# Access Compliance Report

## Public Rights-of-Way

### (Curb Ramps)

Intersection ID: 17028	Main Street: MEADOWDALE_LN	Cross Street: MISSION_HILLS_RD	Location: NE
ADA ID: C593CBB11DA9	Ramp Type: PerpDiag	Initial Pass/Fail: Fail	Overall Compliance: No
Severity Score: 25			
Codes/Mitigation Info/Possible Solution		Field Measurements/Component Compliance

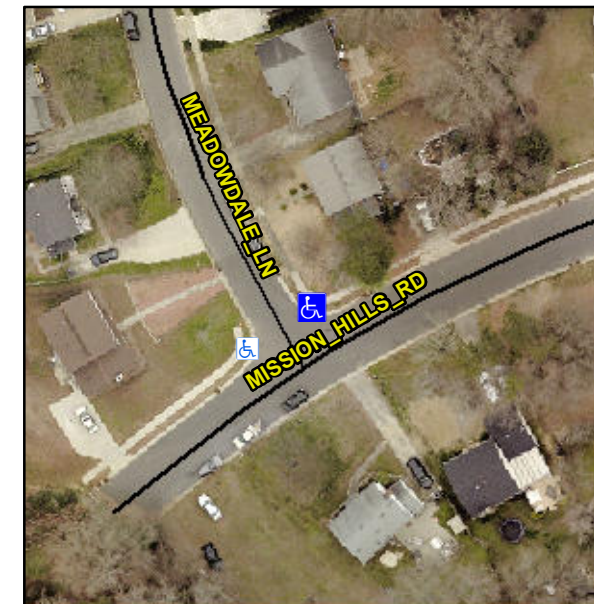
**Not Found, R304.5.3**

Compliance	Description	Data	Compliance	Description	Data
N/A	Ramp Length (in)	47.0	Yes	Ramp Slope (%)	7.6
Yes	Ramp Width (in)	48.0	No	Ramp XSlope (%)	7.6
N/A	Flare Type LT	N/A	N/A	Flare Type RT	N/A
N/A	Flare Slope LT (%)	N/A	N/A	Flare Slope RT (%)	N/A
N/A	Flare Traversable LT?	N/A	N/A	Flare Traversable RT?	N/A
N/A	Landing Length (in)	N/A	N/A	DWS Provided?	N/A
N/A	Landing Width (in)	N/A	N/A	DWS Contrast?	N/A
N/A	Landing Slope (%)	N/A	N/A	DWS Length (in)	N/A
N/A	Landing X Slope (%)	N/A	N/A	DWS Full Width?	N/A
N/A	Landing Curb? (Y/N)	N/A	N/A	DWS Offset (in)	N/A
N/A	Shared Landing?	N/A			
N/A	Gutter Ponding?	N/A	N/A	Gutter Slope (%)	N/A
N/A	Gutter Lip Ht (in)	N/A	N/A	Gutter X Slope (%)	N/A
N/A	Painted X Walk1?	No	N/A	Painted X Walk2?	No
	X Walk 1 Direction	To SW		X Walk 2 Direction	To SE
N/A	X Walk 1 Width (in)	N/A	N/A	X Walk 2 Width (in)	N/A
	X Walk 1 Slope (%)	4.7		X Walk 2 Slope (%)	1.2
	X Walk 1 X Slope (%)	4.2		X Walk 2 X Slope (%)	6.2

**Remove & Replace Curb Ramp With Two New Directional Ramps or Equivalent.**
